***Angler Switch JCT – P82-77 Circuit Switcher Installation  
Notification of Approval of Connection Proposal  
CAA ID Number: 2005-EX241***

## ASSESSMENT SUMMARY

#### *Angler Switch JCT – P82-77 Circuit Switcher Installation* *CAA ID Number: 2005-EX241*

## P82-77 circuit switcher on T1M @ Angler Junction

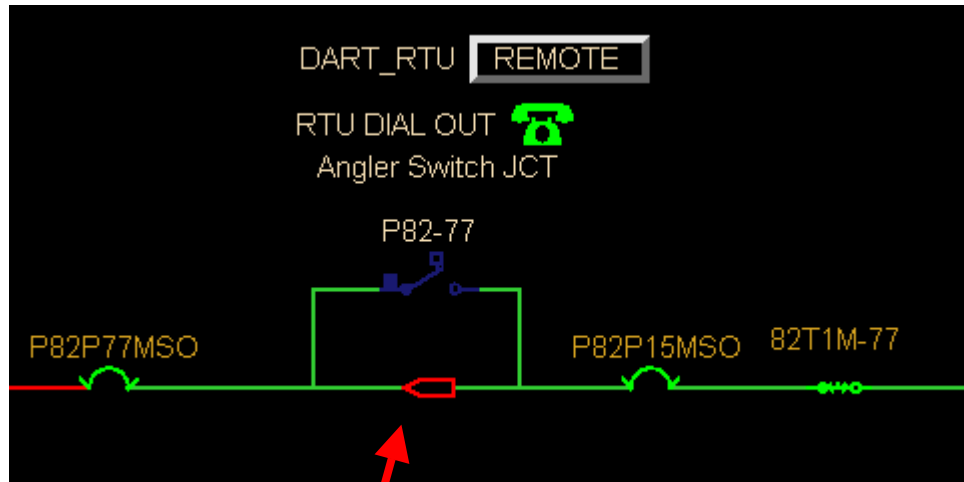
A new circuit switcher (P82-77) is to be installed on the 115kV line T1M at Angler Switch Junction. It will be used to provide underload switching and sectionalization between P82P77MSO and P82P15MSO. The isolation points for this work to be completed are 82T1M-77 and 77T1M-82. The single line diagram showing the new arrangement is attached.

The new circuit switcher is **not** expected to be used for interrupting purposes. Nonetheless, the assessment indicates that the ratings of the proposed installation is adequate for the short circuit levels experienced in the current system.

- The Transmission System Code (Appendix 2) recommends that all 115 kV interrupting devices have an interrupting capability of 50 kA. The new circuit switcher is rated below this performance standard set in the TSC. Since the short circuit levels in the area are well below the maximum levels that are acceptable by the TSC, it can be concluded that the interrupting capability of the new circuit switcher is adequate for the time being. If in the future the short circuit levels are to exceed the interrupting capability of the new circuit switcher, Hydro One Networks Inc. will be required to replace the necessary equipment with adequately rated units.

The Market Rules (Chapter 4 section 7.4) require that transmitters shall provide the IESO on a continual basis with on-line monitored quantities as specified in Appendix 4.16. For this proposed project, the IESO will require the status of the new circuit switcher.

Jumper bypass consisting of 477 ACSR 26/7 stranded conductor has been removed with the paralleling of the P82-77.
